# Darden Clean Energy Project (23-OPT-02)

## CEC Data Request Response Set #1

Figure 1 DR WS-3 Typical BESS Fire Protection Layout

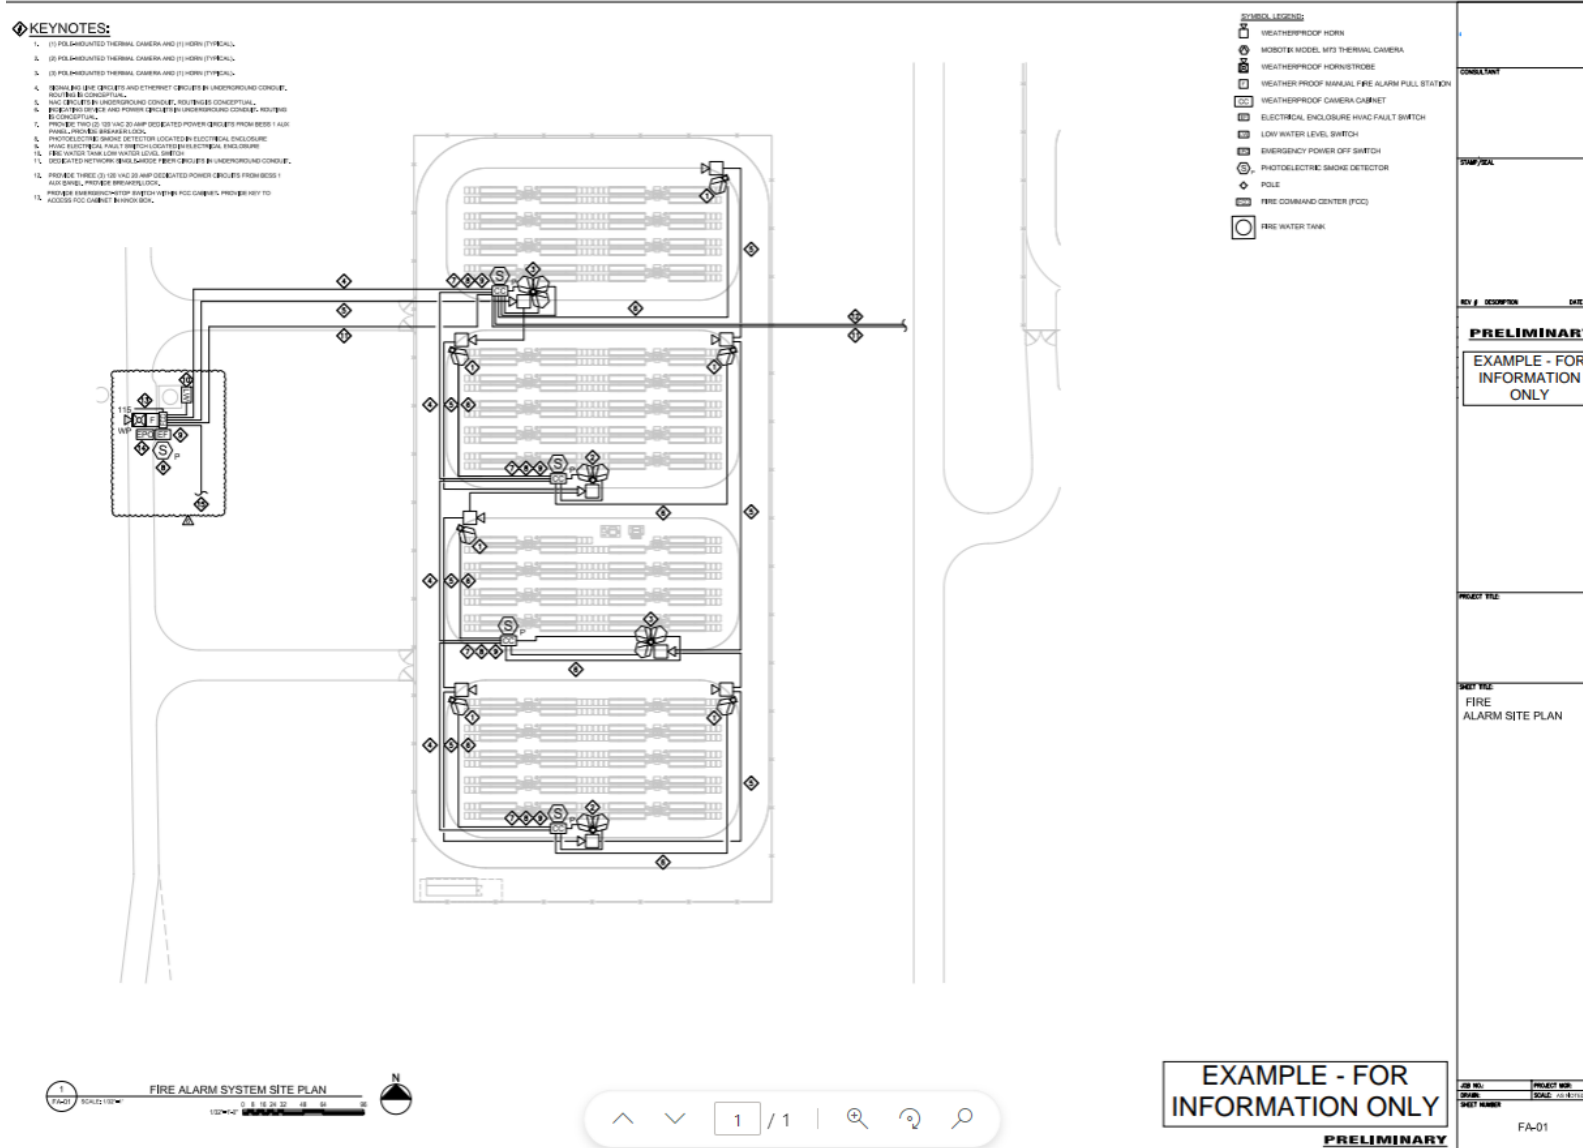
**DR WS-3:** Please provide schematic engineering drawings detailing the location and type of all proposed fire detection, fire suppression, water supply and leak detection equipment for the BESS and Green Hydrogen portions of the project, and the location of hydrants, post indicator valves, and monitors for the fire water loop. Please provide this information for all proposed alternative

locations or state that these systems will be the same. Additionally, please provide how any explosion hazards would be mitigated at the Green Hydrogen and BESS portions of the project.

**Response:** The fire protection philosophy for the hydrogen facility is provided in Appendix P of the Opt-In Application. Design and layout of the facility and safety components will be determined as the engineering and design advances; schematic engineering drawings are not available at this time.

The fire detection drawings for the Project BESS will be developed as detailed engineering continues. The BESS yard will have thermal detection cameras installed externally on battery containers and will be strategically placed in optimal locations to detect fires. These cameras will be remotely monitored 24 hours a day. There will be up to four emergency 15,000-gallon water tanks for the Project, based on final layout. A typical BESS fire protection layout is provided in Figure 1 below and is discussed in the response to DR HAZ-7. The final number and location of water tanks for emergency use will be determined in accordance with California Fire Code and be reviewed/approved by the local or State Fire Marshal.

The BESS equipment selected for the Project will be tested pursuant to UL 9540A standards, and the Project will be designed and built pursuant to UL and NFPA codes. The BESS equipment to be used will be tested to demonstrate that they do not require built-in smoke, gas, or fire detection or suppression devices.

The BESS equipment will be designed to minimize the risk of an over-pressure event and deflagration through the use of over-pressure vents and a sparker system. These safety features will be tested pursuant to UL 9540A standards to demonstrate their effectiveness in preventing deflagration in a large-scale fire.
